STAFF REPORT 9-11-2019 MEETING PREPARED BY: J. ROSS

APPLICATION NUMBER 19-6428

ADDRESS: 1658 LEVERETTE

SCOPE: PAINT HOUSE

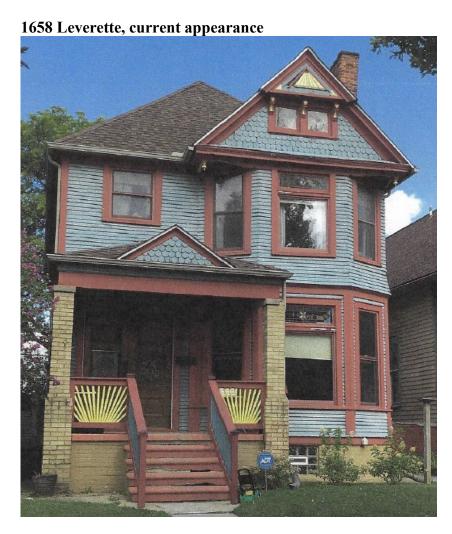
- Please note that staff does have the authority to approve new paint colors, as long as the scheme conforms to the property's assigned HDC color chart. In this case, the home's assigned color chart is system B (see the attached). Staff has forwarded the current application to this body for review because the proposed color scheme does not conform to the home's assigned color system.

- As noted in the above-referenced Element of Design #9, homes within the district are not typically monochrome in color. Rather, colors typically highlight the home's exterior elements, with the body, sash, and trim being painted different colors

The proposed work/new paint is "reversible" and thus will not destroy historic materials which characterize the home and/or the district. Also, the Elements of Design for the district note that Queen Anne homes within the neighborhood "...sometimes display richer and darker colors, such as ...blues." Staff therefore recommends that the Commission issue a Certificate of Appropriateness for the work as proposed because it meets the Secretary of the Interior Standards for Rehabilitation, standard # 2) The historic character of a property shall be retained and preserved. The removal of historic materials or alteration of features and spaces that characterize a property shall be avoided; #9) New additions, exterior alterations, or related new construction shall not destroy historic materials that characterize the property. The new work shall be differentiated from the old and shall be compatible with the massing, size, scale, and architectural features to protect the historic integrity of the property and its environment.

Victorian house colors ideas 92

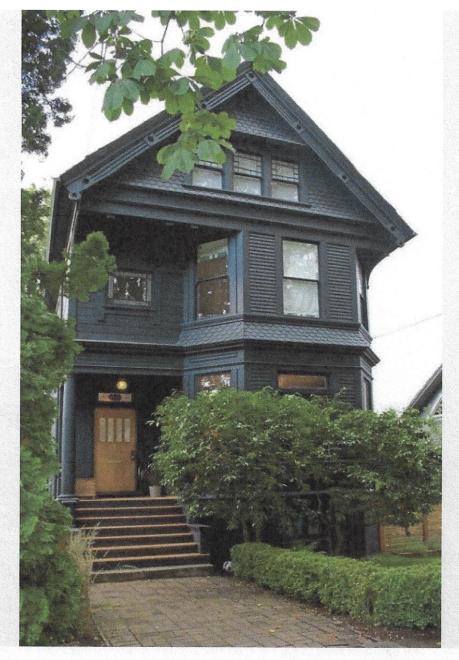
- Sherwin Williams Gale Force (SW 7605, locator# 279-C3) shall be applied to the body, trim, window sash, porch, porch steps, and all decorative accents. See the below photo, which provides a precedent for the proposed paint scheme.
- The existing unpainted chimney brick (at the roof) and the front porch columns will remain unpainted
- The portion of the chimney which is currently painted (below the roof, at the east elevation) and the foundation wall will be repainted according to the existing color (Sherwin Williams 6124, Cardboard).
